Model: S-P3	Date: 07-Jun-11	No.: RM080001a
-------------	-----------------	----------------

Subject: Firmware Release Note: Engine		Prepared by: K.Nakano	
From: 2nd Tech Service Sect., MFP/Printer Tech Service Dept			
Classification:	<input type="checkbox"/> Troubleshooting <input type="checkbox"/> Mechanical <input type="checkbox"/> Paper path <input type="checkbox"/> Product Safety	<input type="checkbox"/> Part information <input type="checkbox"/> Electrical <input type="checkbox"/> Transmit/receive <input checked="" type="checkbox"/> Other (Firmware)	<input type="checkbox"/> Action required <input type="checkbox"/> Service manual revision <input type="checkbox"/> Retrofit information <input checked="" type="checkbox"/> Tier 2

This RTB has been issued to announce the firmware release information for the **Engine**.

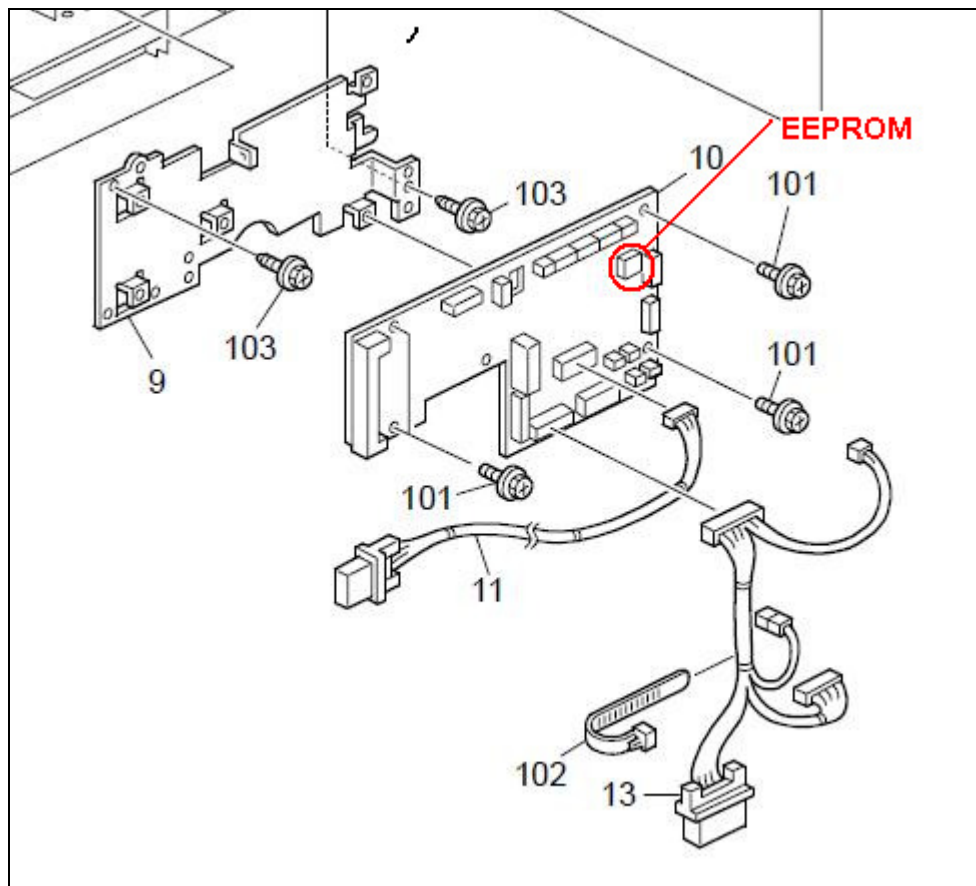
The part number for the EEPROM of the Engine Board was missing from the Parts Catalog.

P/N	Description	Q'ty	Page
1407 6657	EEPROM:BR93L76-W	1	26

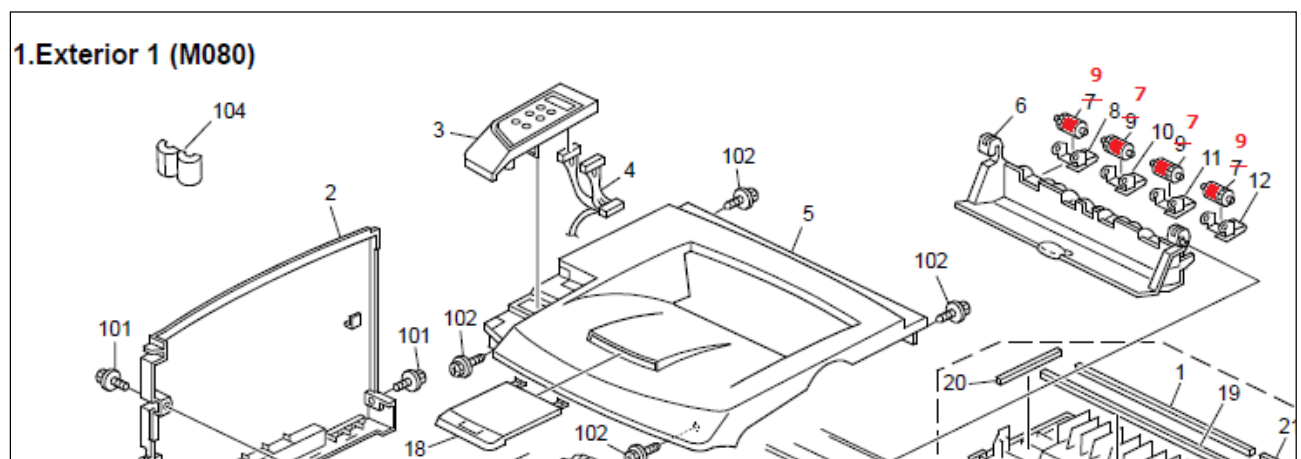
**Reason:** Model S-P3 is not compliant with the international Energy Star standard Ver 2.0. of 2014.

Old part number	New part number	Description	Q'ty	Int	Page	Index	Note
AA001477	N/A	DECAL:ENERGY-STAR	0	X/X	31	20

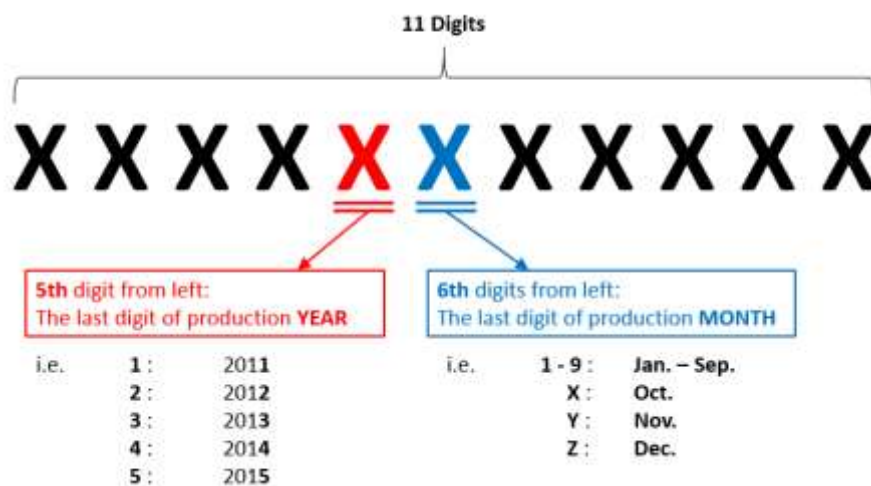
Dirty background occurs or the side of the paper stack is dirty after installing a new AIO. This cannot be cleared by printing out a large volume of pages.

The space in the AIO through which developer is supplied to development roller is too narrow. As a result, the amount of developer supplied decreases, which raises the toner concentration.

Replace the AIO with one produced in **November 2014 or later**.
